## PRODUCT SUPPORT BULLETIN BULLETIN NO. 309

MACHINE: **LS Auto-Lift**

SUBJECT: **Single/Dual Extend Select Switch Kit - 98790016**

**Figure 1**

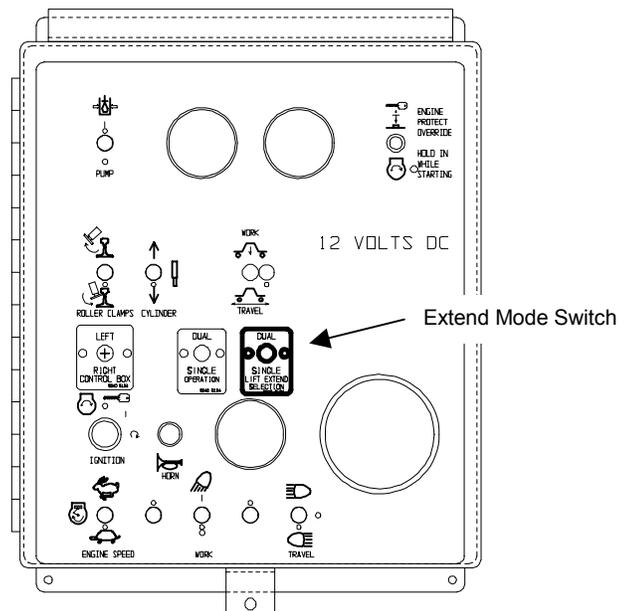
If the customer would like the option of using both extend modes, this kit may be installed on the Main Control Box to switch between modes. Refer to Figure 1

With this switch in the "DUAL" position, both lift cylinders will raise when either extend button is pushed. With the switch in the "SINGLE" position, only one lift cylinder will raise when the corresponding extend button is pushed.

This kit includes a **Toggle Switch, p/n 5123593, Plaque, p/n 56405155**, wire, hardware and instructions. This kit can be installed in about 1 hour.
